ARCHITECTURAL ADDENDUM ADD #2

December 14, 2022

Re: **Hilliard Township Office Addition**
951678 Hwy 569
Hilliardton, ON P0J 1P0

Project No. **22013**

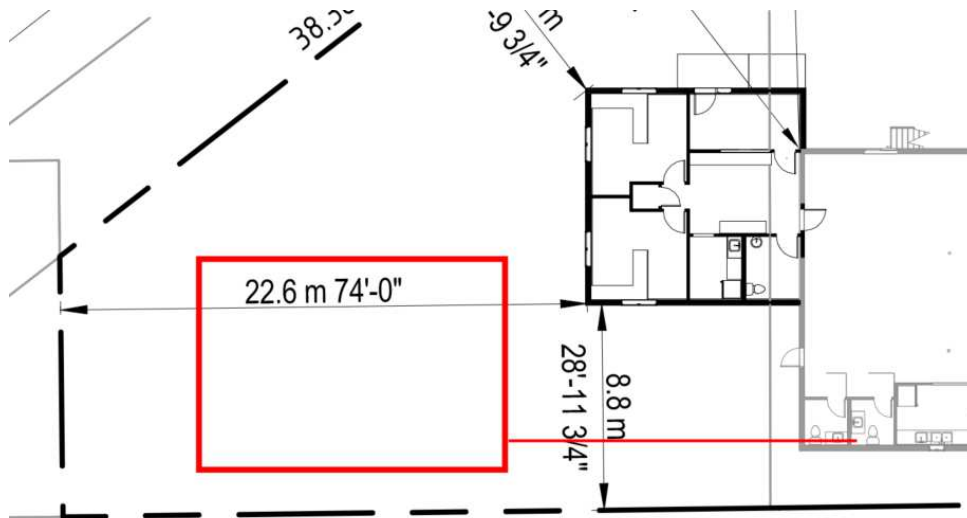
Q3: Where is the sewer located?

A3: The existing septic system is located in the general area shown below. The sanitary discharge pipe is located in the washroom.

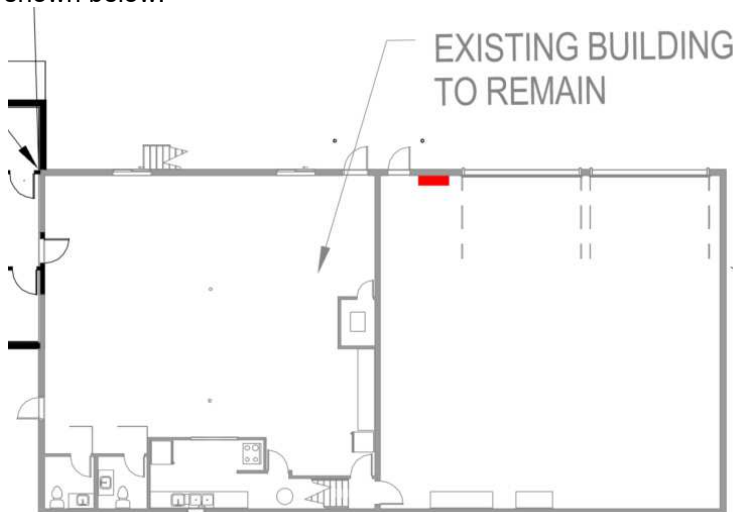
Q3: Where are the existing electrical panels located?

A3: On the East wall in the existing shop area, between the man door and the overhead garage door as shown below:

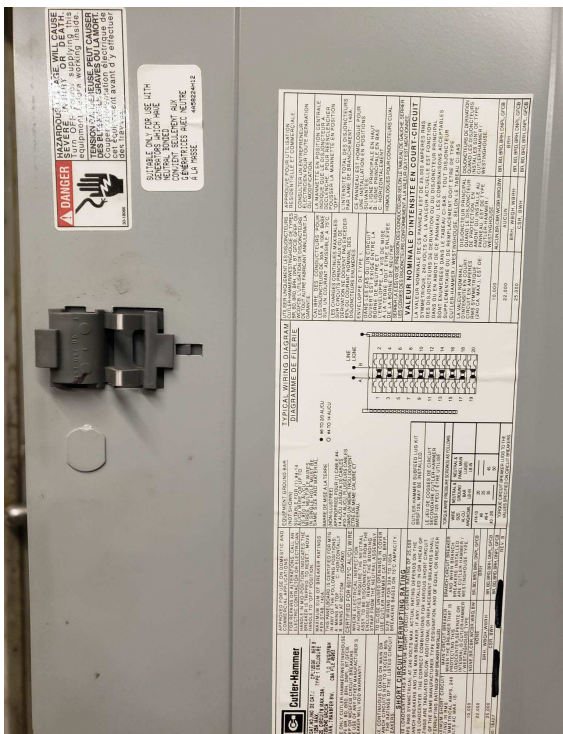
- Q4: Is there sufficient capacity in the existing electrical panel to serve the new addition?
- A4: The contractor shall assume that the existing electrical panels need to be completely replaced to accommodate the new addition. The images below show the two existing electrical panels:
